**Warrnambool Asphalt Batch Plant  
Fulton Hogan**

**Response to Council RFI**

Planning Permit Application # PP2022-0016

Figure 1 Potential residential areas (interpreted from Council structure plans). Blue star indicates approximate site location.

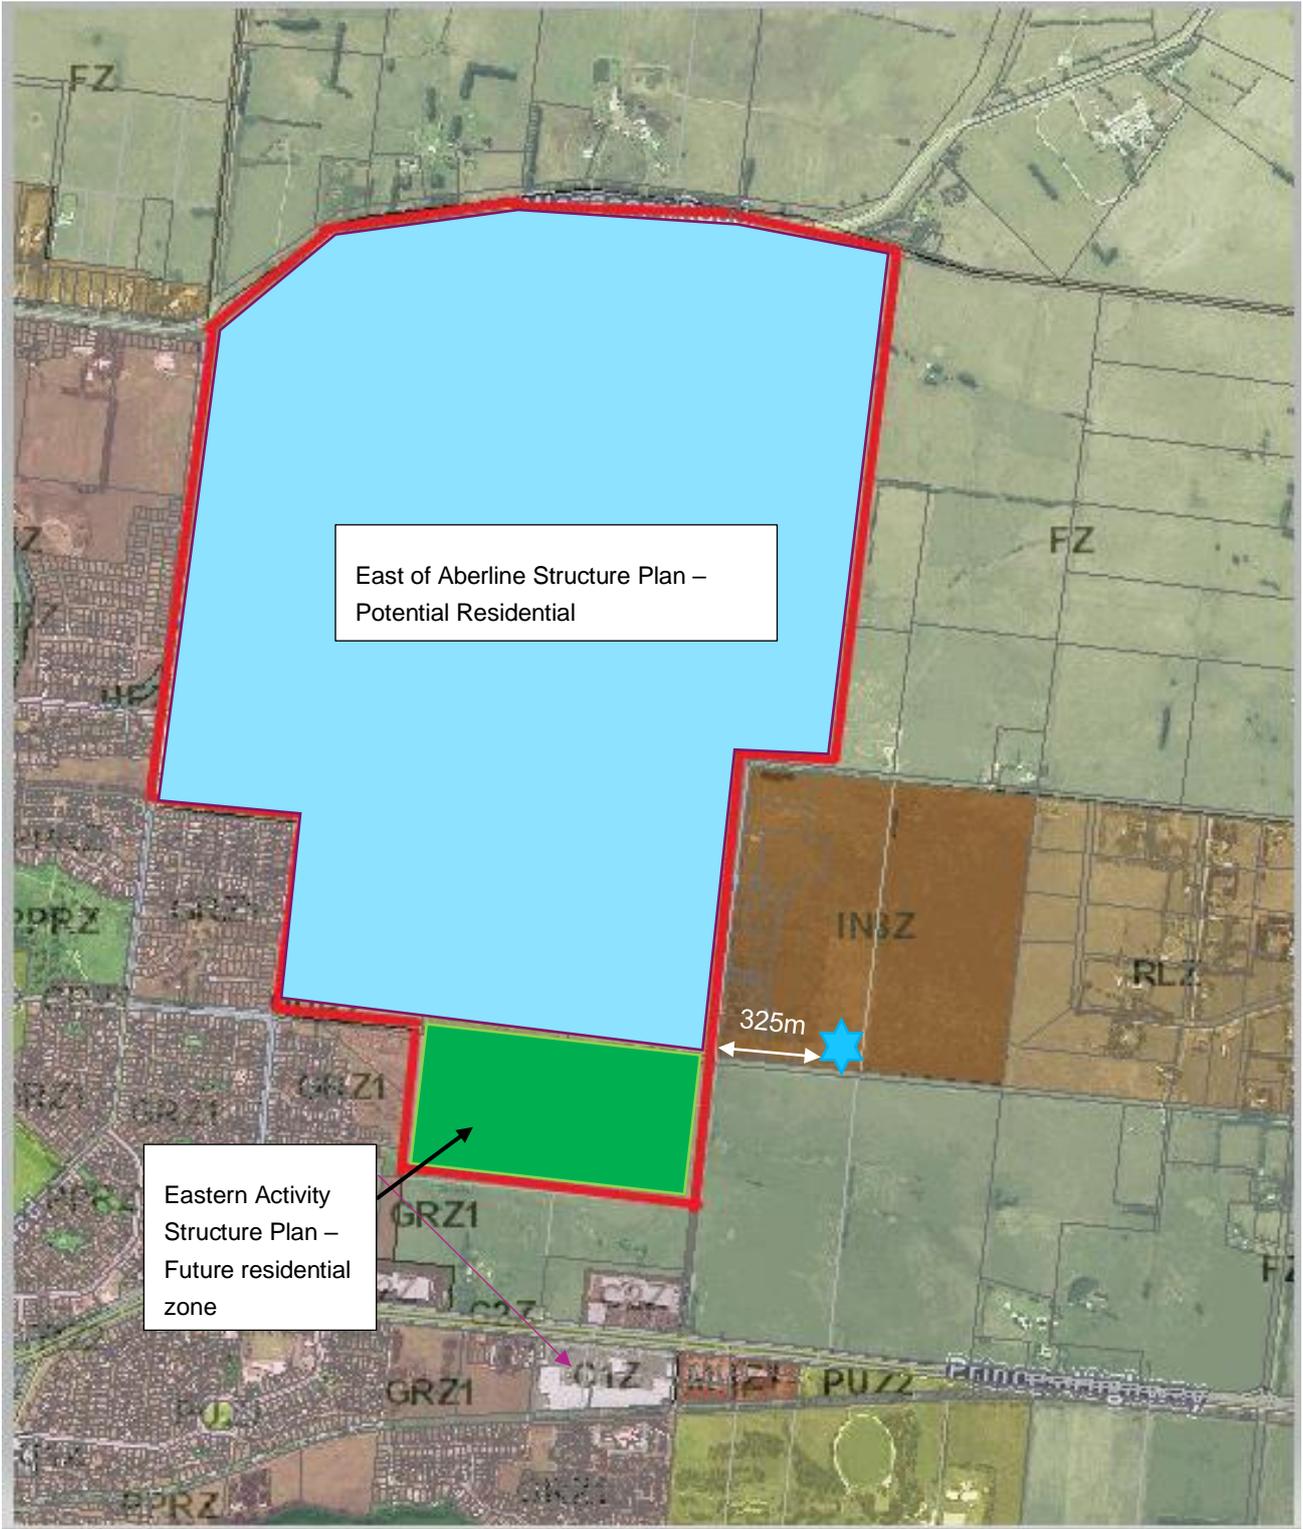
- *Although acknowledged that you can't provide for all future eventualities, all reports fail to consider land identified for future residential as per the structure plan.*

- *The acoustic report analyses areas further out (140 Boiling Down, 21 Veal at 600-700m), but fails to make mention of the existing RLZ at 400m, or the potential GRZ at 325m.*

- *The air quality report also fails to acknowledge the possible GRZ.*
- *Both the air quality and acoustic reports fail to use specific sensitive receivers which would be essential in understanding how this particular context will meet the various requirements under the planning scheme. In order to prove that the proposal can meet the objectives in its specific context, it needs justification from all three reports using the sensitive receivers that exist in context, and analysed with the localized conditions that will influence the outcome. "*

Figure 1 presents the potential residential areas that have been derived and interpreted from mapping within the Eastern Activity Structure Plan and East of Aberline Structure Plan boundary. The distance from the proposed site to this potential residential area is approximately 325 m at its nearest point (equidistant to each of the structure plan residential areas; refer to Figure 1).

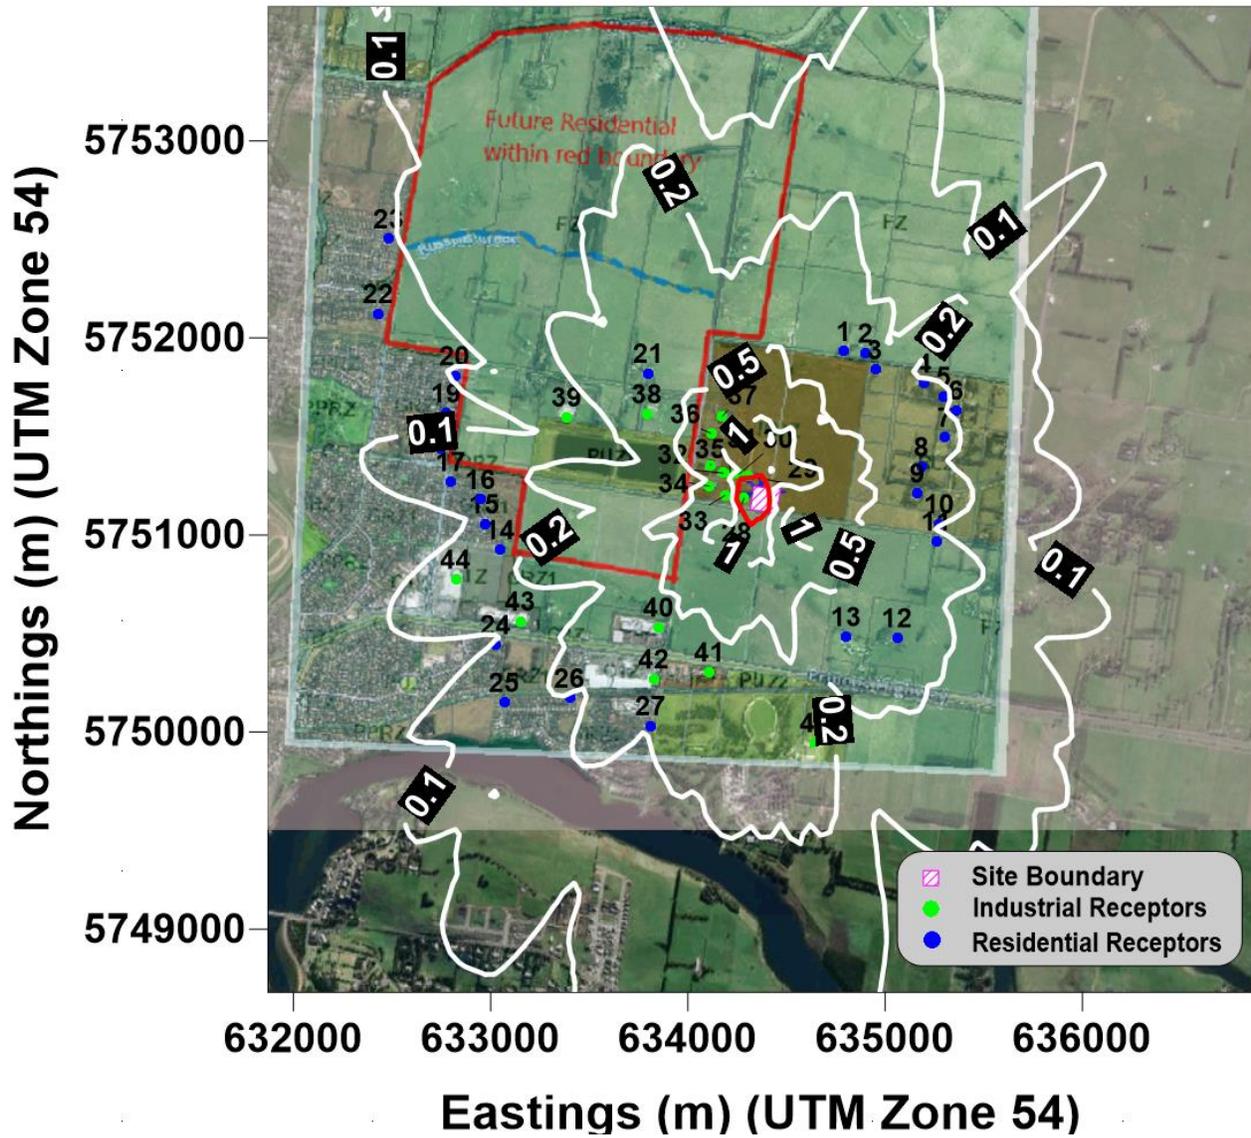
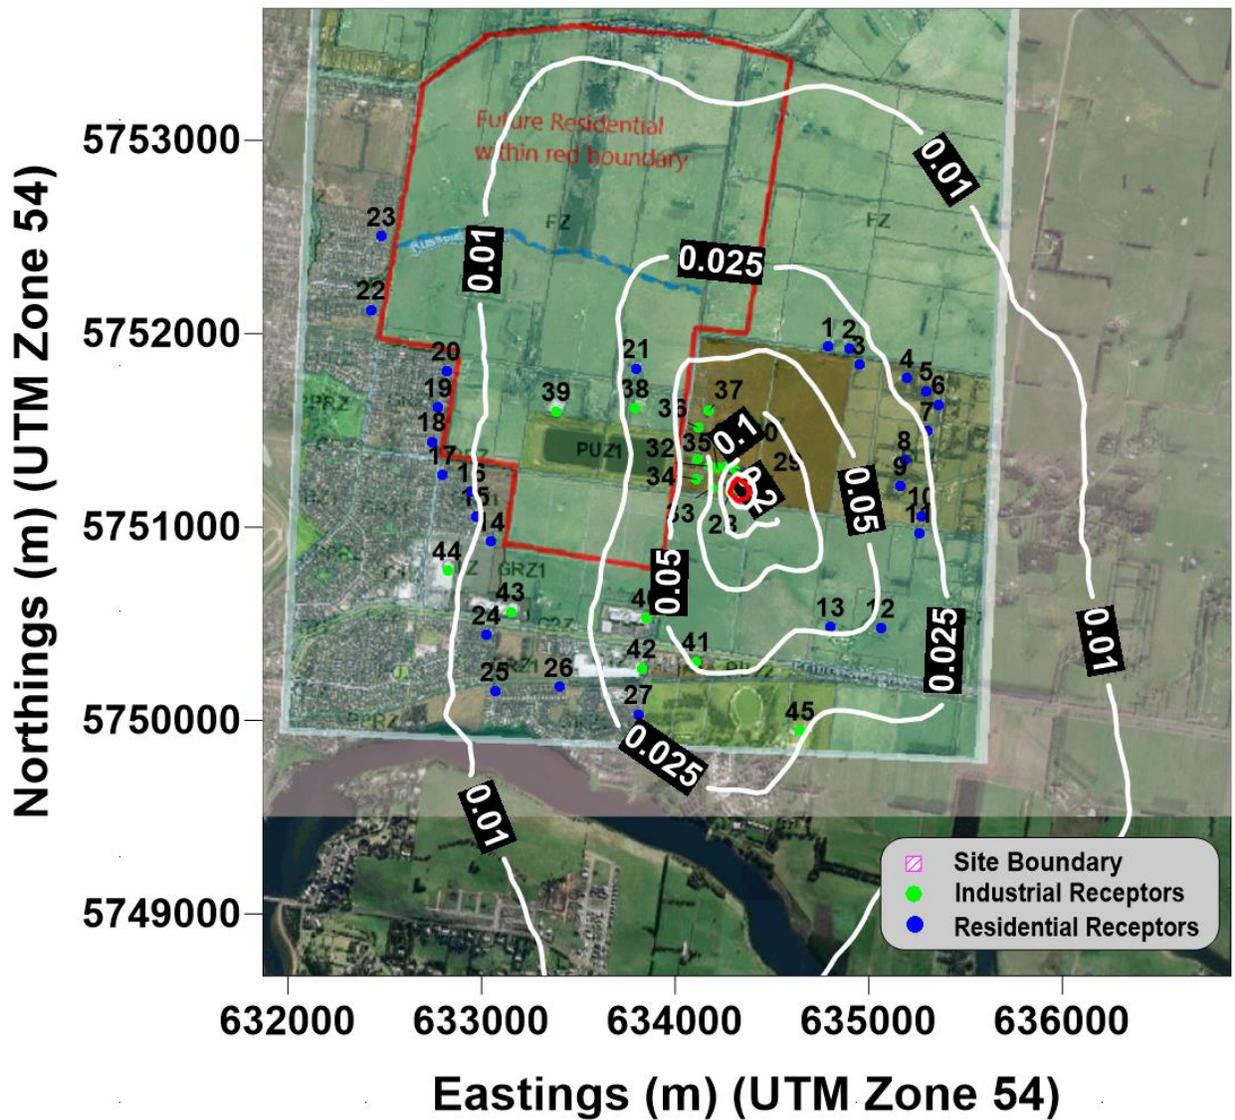
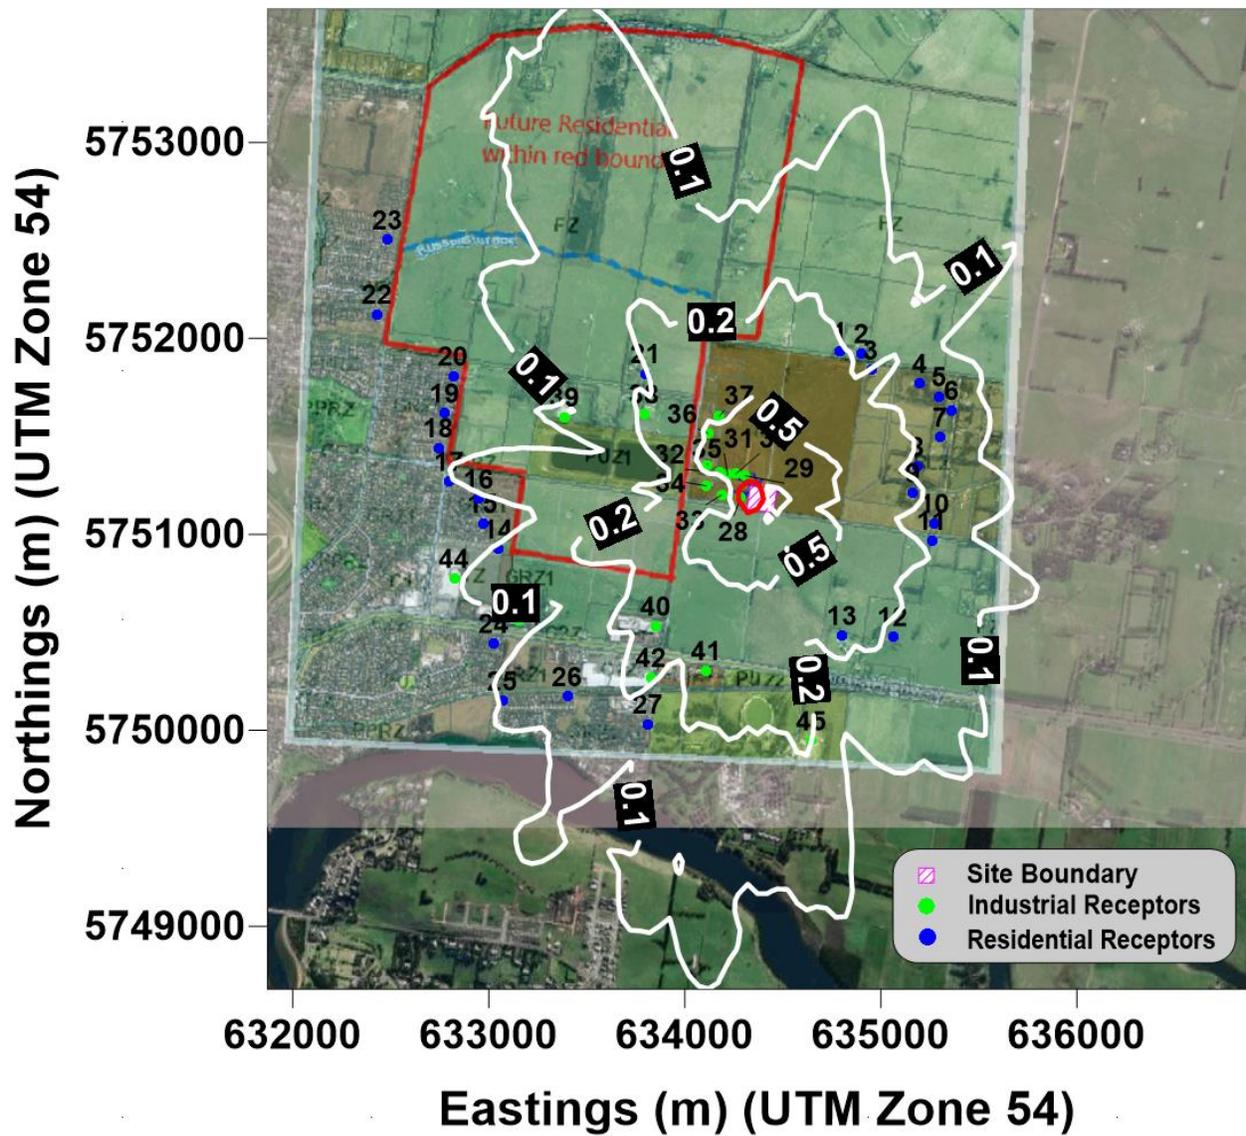
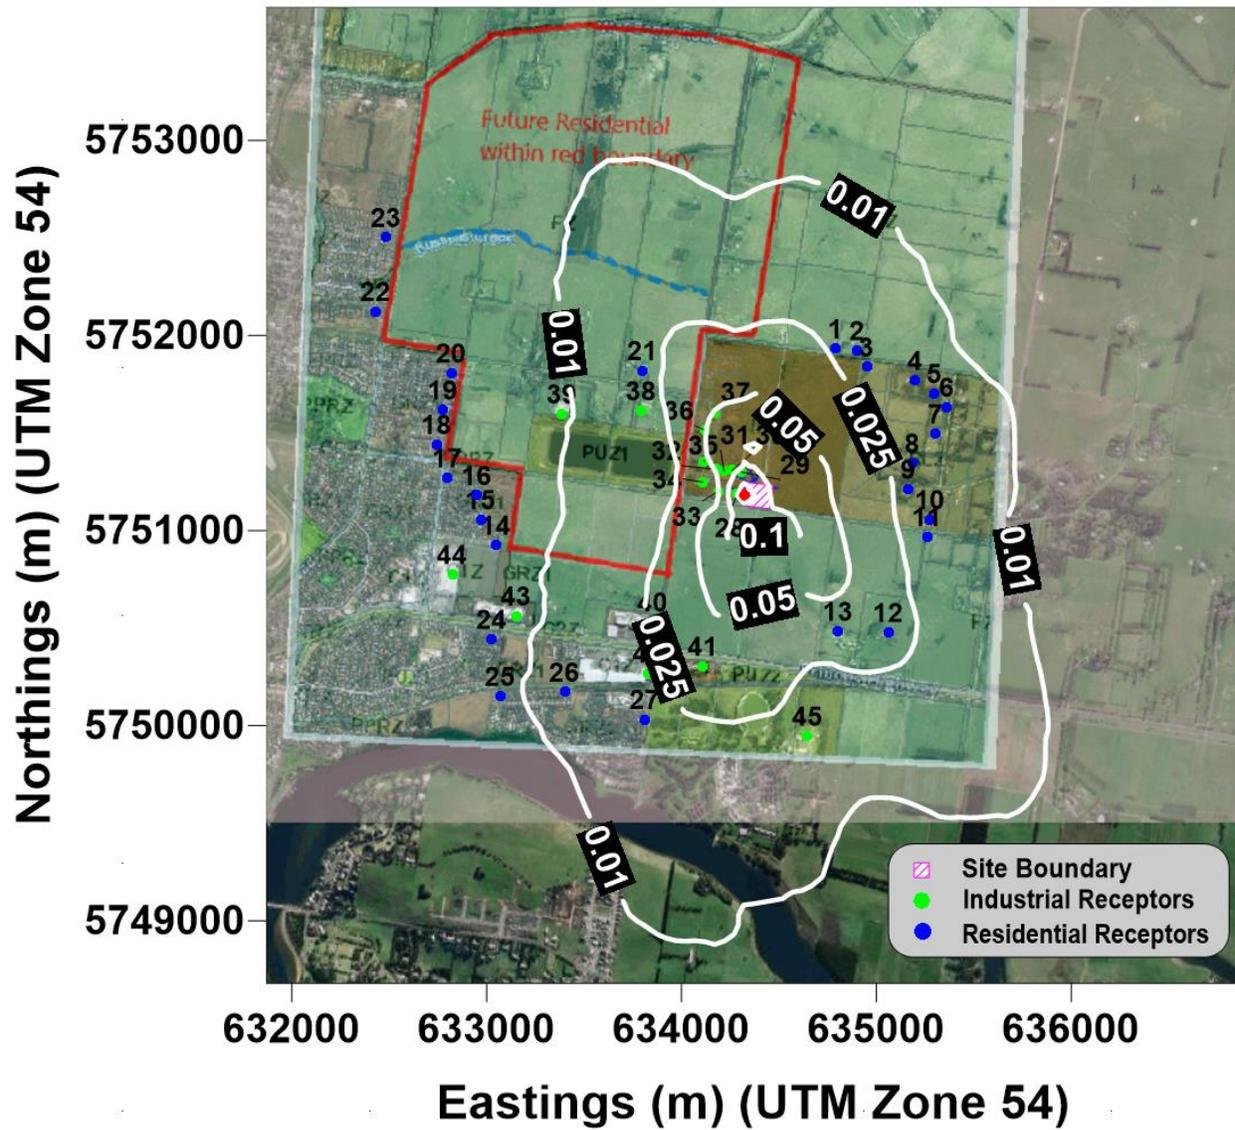
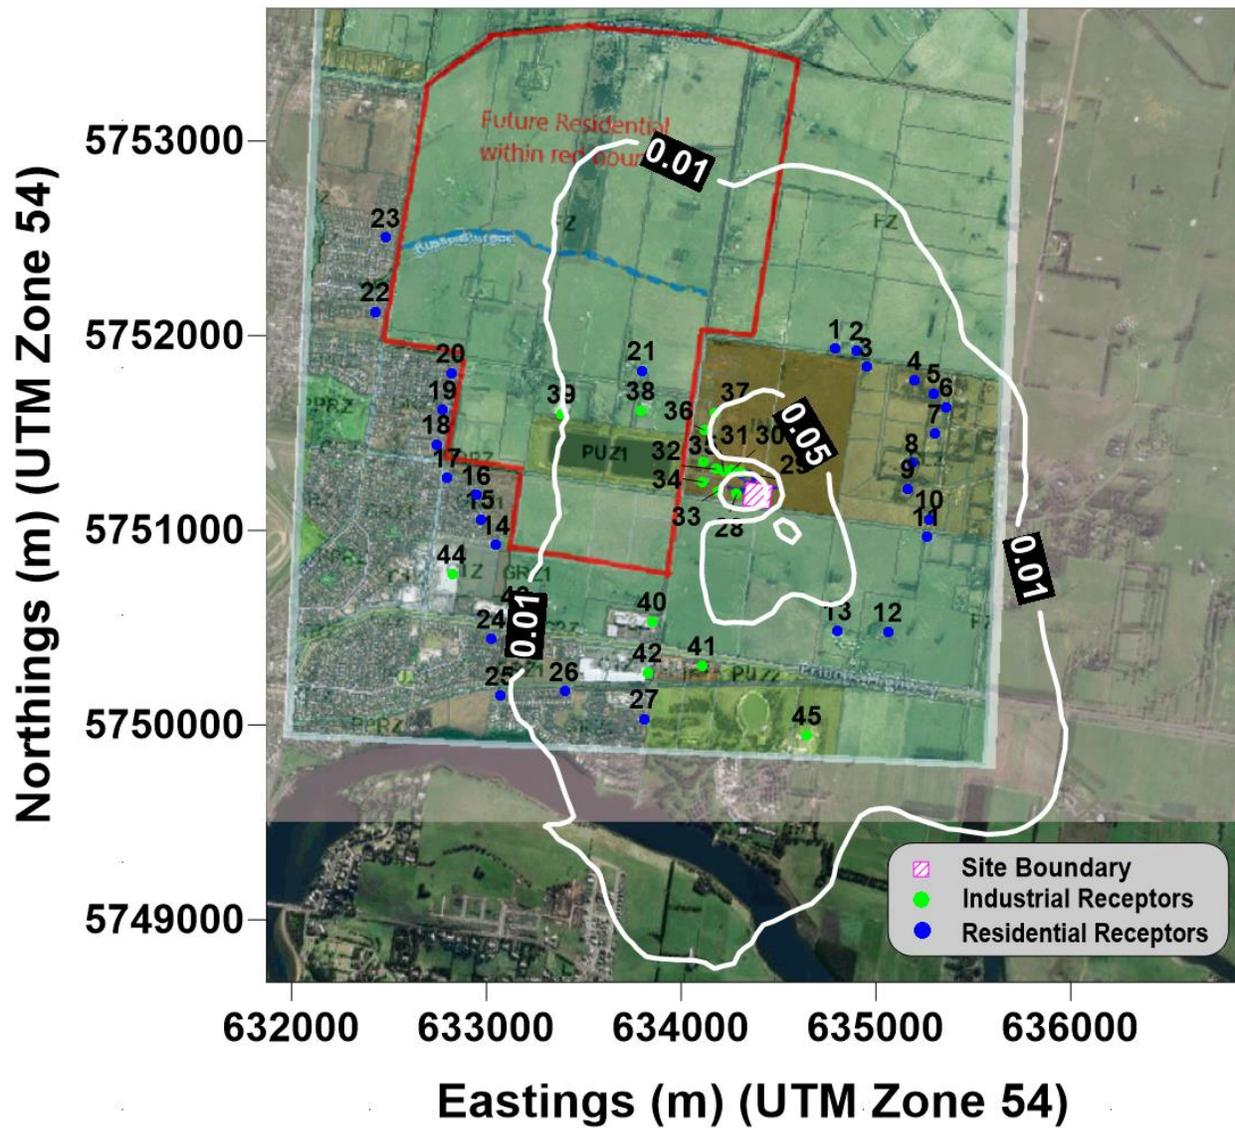
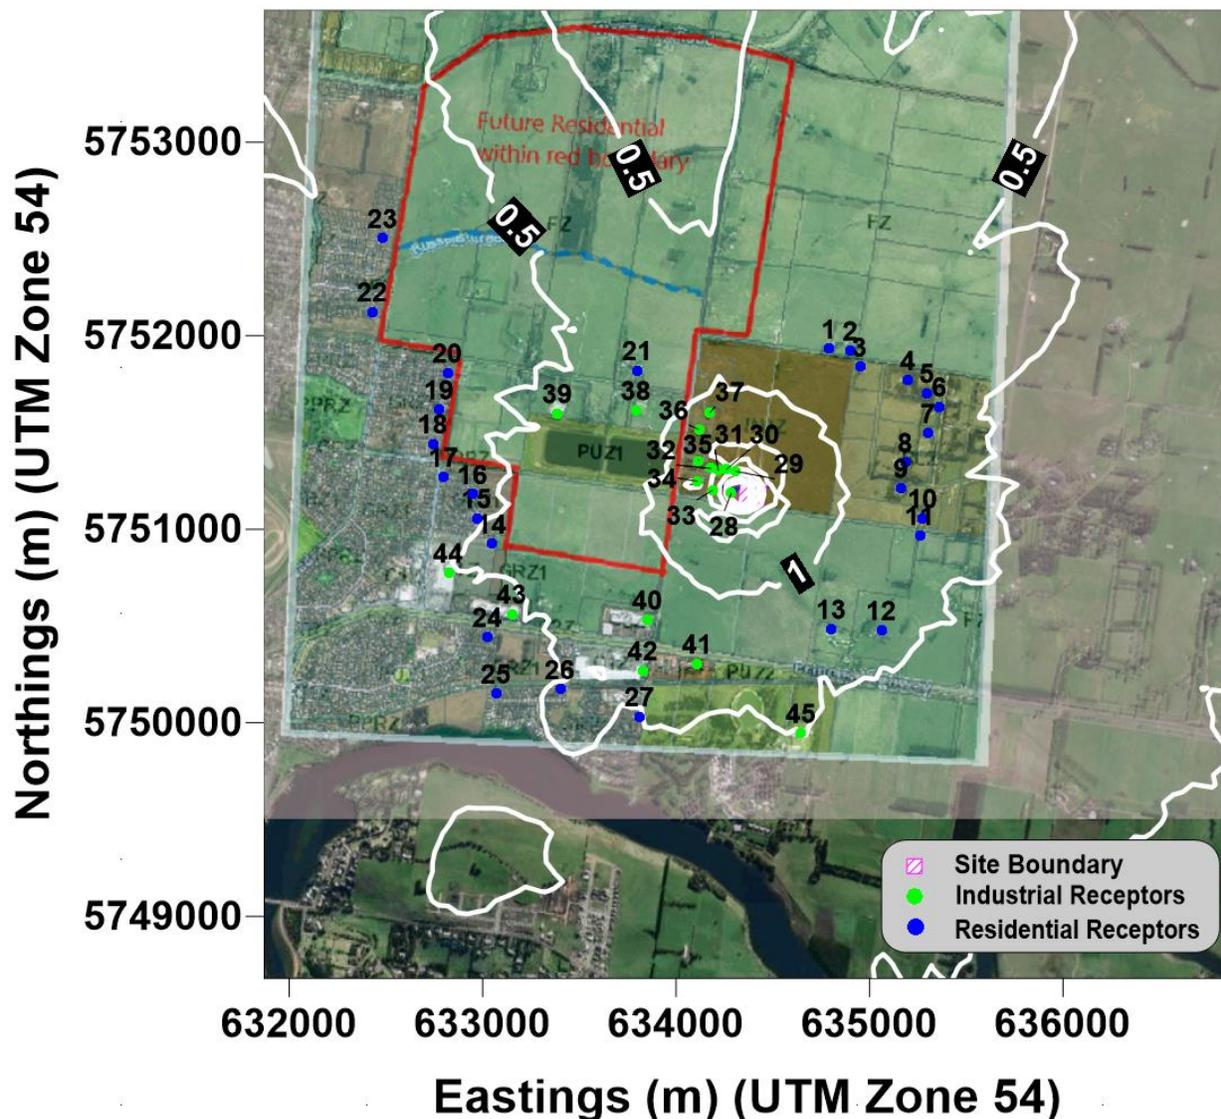
- *Although acknowledged that you can't provide for all future eventualities, all reports fail to consider land identified for future residential as per the structure plan,*
- *The air quality report fails to acknowledge the possible GRZ, and*
- *Both the air quality and acoustic reports fail to use specific sensitive receivers which would be essential in understanding how this particular context will meet the various requirements under the planning scheme. In order to prove that the proposal can meet the objectives in its specific context, it needs justification from all three reports using the sensitive receivers that exist in context and analysed with the localised conditions that will influence the outcome.*

Concentration isopleths for a selection of the modelled pollutants overlaid on the existing RLZ and potential GRZ have been presented in **Figure 2** through to **Figure 11**. It is to be noted that concentration isopleths have been presented as incremental impacts (i.e. impacts from the proposed development only).

Upon examining the concentration isopleths presented in **Figure 2** through to **Figure 11**, it is observed that the isopleths show relatively consistent reduction in pollutant concentrations with distance from site implying that receptors further from the site will experience lower concentrations than those closer to the site. Now as per the Airlabs report, all sensitive receptors many of which were much closer to the site than the existing RLZ and potential GRZ were compliant with the criteria and therefore the implication is that the existing RLZ and potential GRZ land parcel too are compliant. It is acknowledged that the concentration isopleths overlaid on the existing RLZ and potential GRZ land parcels are incremental impacts (i.e. contribution from the proposed development only) and not the cumulative impacts (incremental + background). However, examination of the modelling results presented in the Airlabs Report clearly shows that cumulative ground level concentrations for all the modelled pollutants comply with the relevant assessment criteria across all of the 45 sensitive receptors and also that the background concentrations are the main contributor for the cumulative concentrations, which indicate the limited contribution expected from the proposed development. Therefore, isopleths have been presented only for the incremental impacts to understand the proposed development's expected impacts on the existing RLZ and potential GRZ land parcels.

Therefore, based on the above discussions and the concentration isopleths presented in **Figure 2** through to **Figure 11**, it is clearly evident that the proposed development activities would be compliant with the air quality criteria at the existing RLZ and potential GRZ land parcels.
